## **Proposal for Amendment 4 of the Mutual Resolution No. 1 (M.R.1) of the 1958 and the 1998 Agreements**

### **Submitted by the Chair (Republic of Korea) of the Informal Working Group on the Deployable Pedestrian Protection Systems of UN Global Technical Regulation No. 9.**

The text reproduced below was prepared by the experts of the Informal Working Group (IWG) of the Deployable Pedestrian Protection Systems (IWG-DPPS) on UN Global Technical Regulation No. 9 to amend the Addendum 5 on provisions for the DPPS Generic Vehicle (GV) Models. The modifications of the existing text of the Working Document ECE/TRANS/WP.29/GRSP/2023/7e are marked in bold for new or strikethrough for deleted characters.

Figure 3  
Components of the generic vehicle models to represent generic structure

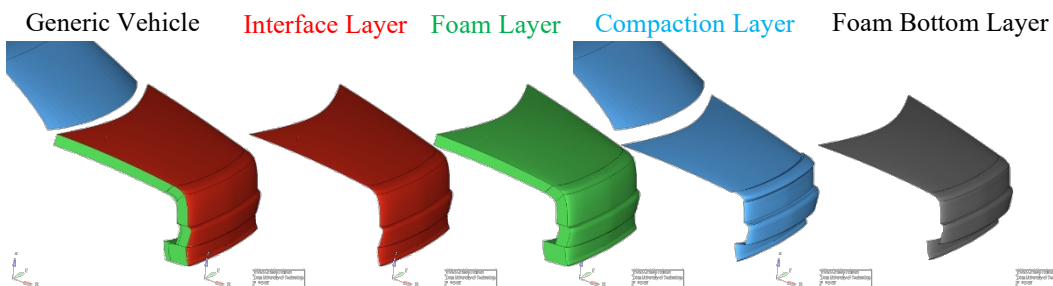
*Amend as follows (move figure 3 after 3.2.1 and delete it after 3.2.2):*

3.2.1. The generic vehicle model consists of the components shown in Figure 43. The structural response is modelled through an outer shell surface, an interface layer, (for modelling the vehicles fascia), a generic foam (to model energy absorbing structures like ribs), resting on the bottom layer (a rigid skeletal vehicle structure) and the compaction layer which works a hard stop.

Impact locations for GV-certification plausibility check

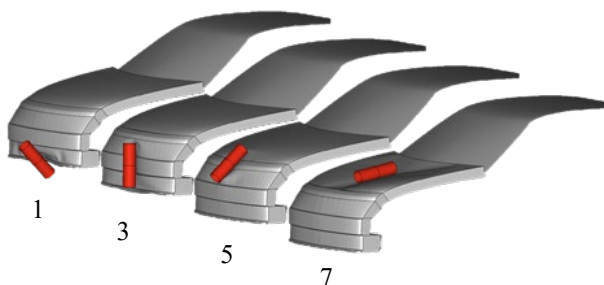
- 4.2. To perform the comparison, the files specified in Annex 2 for the respective FE code, vehicle shape and impactor location shall be used. Impacts shall be performed with the rigid cylindrical impactor (density= 7.89 E-6 kg/mm<sup>3</sup>, diameter= 120 mm, height= 400 mm and wall thickness= 5 mm) at the vehicle centreline on the spoiler (ID=1), Bumper (ID=3), Bonnet Leading Edge (ID=5) and bonnet (ID=7), as shown in the figure below.
